CITY PLAN COMMISSION**THURSDAY, APRIL 10, 2025****FILE NUMBER:** S245-124**SENIOR PLANNER:** Hema Sharma**LOCATION:** bounded by Cadiz Street, Saint Paul Street, Corsicana Street and Ervay Street**DATE FILED:** March 12, 2025**ZONING:** CA-1(A)**CITY COUNCIL DISTRICT:** 2**SIZE OF REQUEST:** 2.3359-acres**APPLICANT/OWNER:** Michael Garcia, Dallas Independent School District, Millet Holdings LP, Millet the Printer, Inc.**REQUEST:** An application to replat a 2.3359-acre tract of land containing all of Lots 1 through 8 in City Block 8/104 to create one lot on property bounded by Cadiz Street, Saint Paul Street, Corsicana Street and Ervay Street.**SUBDIVISION HISTORY:**

CLHS ADDITION
LOT 1R, BLOCK 8/104
REPLAT

[illegible]PRELIMINARY PLAT
OF

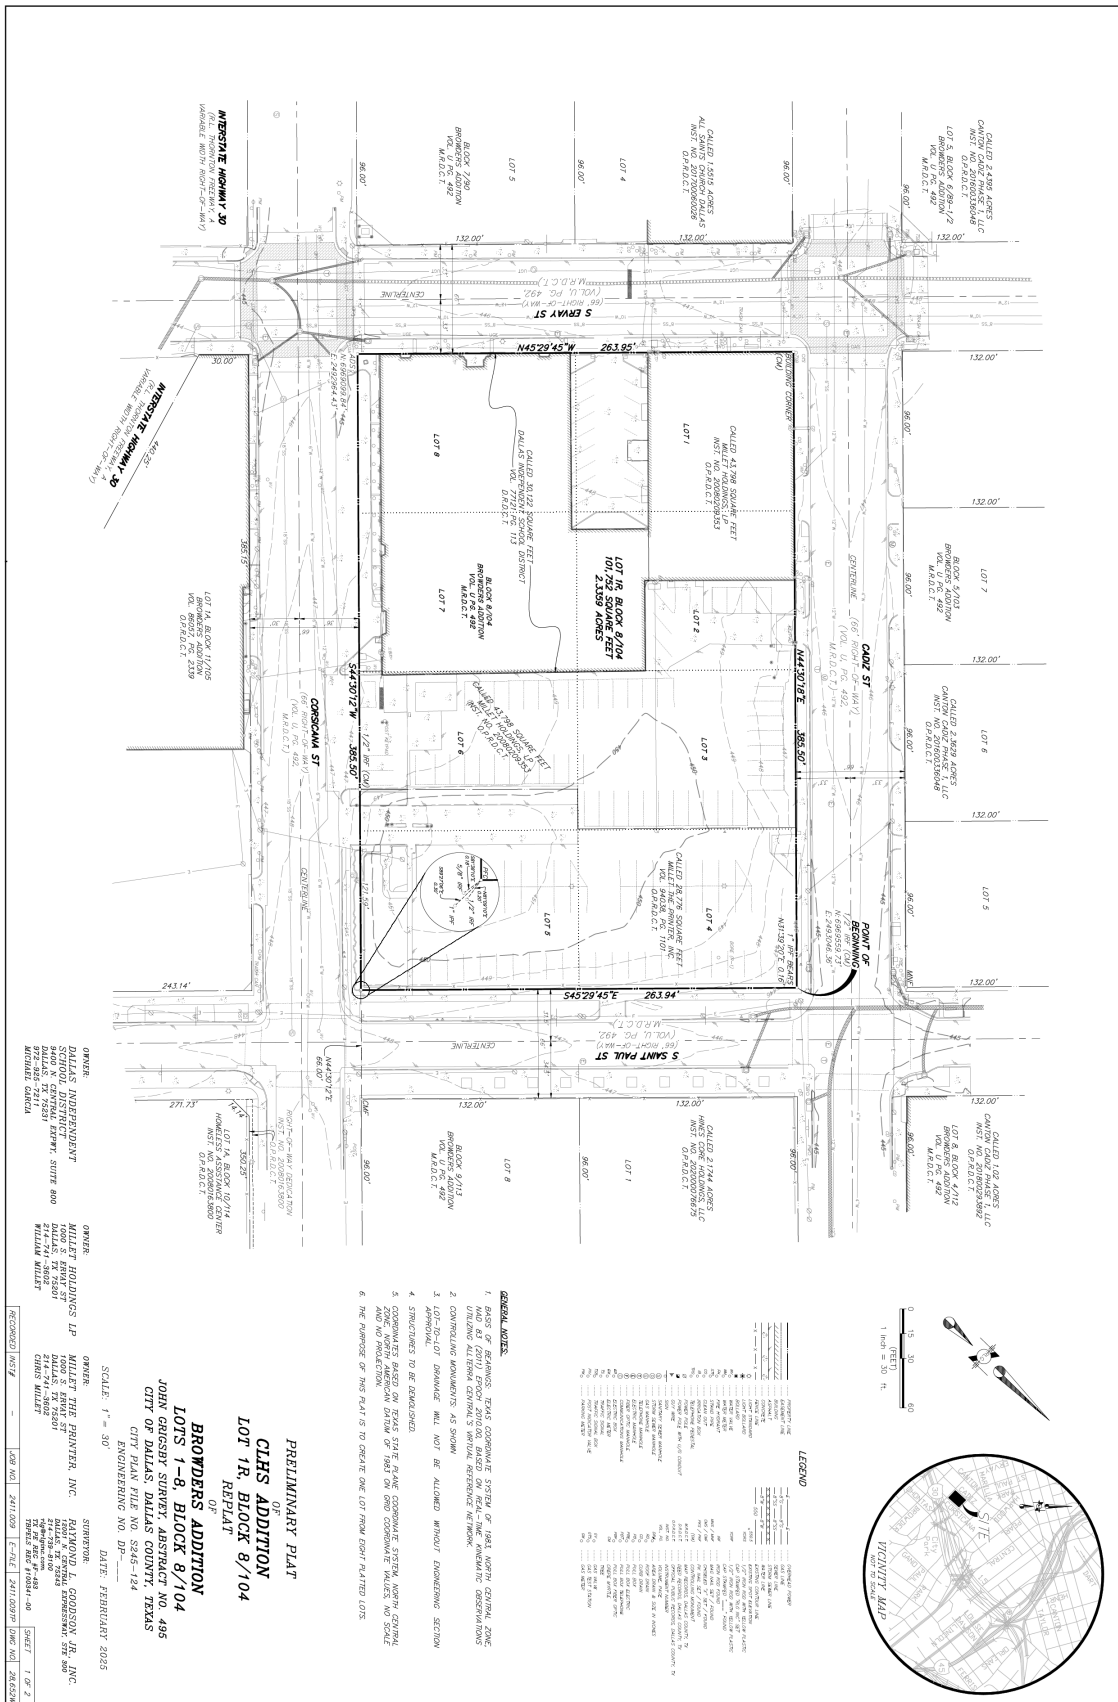
15. On the final plat, dedicate 33 feet of right-of-way (via fee simple) from the established center line of Saint Paul Street. *Section 51A 8.602(c)*
16. On the final plat, dedicate 33 feet of right-of-way (via fee simple) from the established center line of Cadiz Street. *Section 51A 8.602(c)*
17. On the final plat, dedicate 33 feet of right-of-way (via fee simple) from the established center line of Ervay Street. *Section 51A 8.602(c)*
18. On the final plat, dedicate a minimum 15-foot by 15-foot corner clip (via fee simple or street easement) at the intersection of Ervay Street & Cadiz Street. *Section 51A 8.602(d)(1)*

19. On the final plat, dedicate a minimum 15-foot by 15-foot corner clip (via fee simple or street easement) at the intersection of Cadiz Street & Saint Paul Street. Section 51A 8.602(d)(1)

20. On the final plat, dedicate a minimum 10-foot by 10-foot corner clip (via fee simple or street easement) at the intersection of Saint Paul Street & Corsicana Street. Section 51A 8.602(d)(1)

21. On the final plat, dedicate a minimum 5-foot by 5-foot corner clip (via fee simple or street easement) at the intersection of Corsicana Street & Ervay Street. Section 51A 8.602(d)(1)

24. On the final plat, Comply with Mill Creek drainage requirements. Finish floor elevation must be 3' above nearest inlet, top of curb. 51A 8.611(d), C.9 of Mill Creek, Master Drainage Plan Study

25. Prior to final plat, submit a completed final plat checklist and all supporting documents.
26. Prior to final plat, clarify any public sanitary sewer lines on the property.

32. Prior to final plat, compliance with City's street lighting standards including illumination standards, material, installation, and activation per Street Design Manual.
33. On the final plat, change "S. St Paul St" to "Saint Paul Street (FKA Evergreen Street)". Section 51A-8.403(a)(1)(A)(xii).
34. On the final plat, change "S Ervay St" to "Ervay Street". Section 51A-8.403(a)(1)(A)(xii).
35. On the final plat, change "Corsicana St" to "Corsicana Street. Section 51A-8.403(a)(1)(A)(xii)
36. On the final plat, change "Cadiz St" to "Cadiz Street". Section 51A-8.403(a)(1)(A)(xii).
37. On the final plat, change "Interstate Highway 30 (R.L. Thornton Freeway)" to R.L. Thornton Freeway/Interstate Highway No. 30" Section 51A-8.403(a)(1)(A)(xii).
38. On the final plat, identify the property as Lot 1A in City Block 8/104.
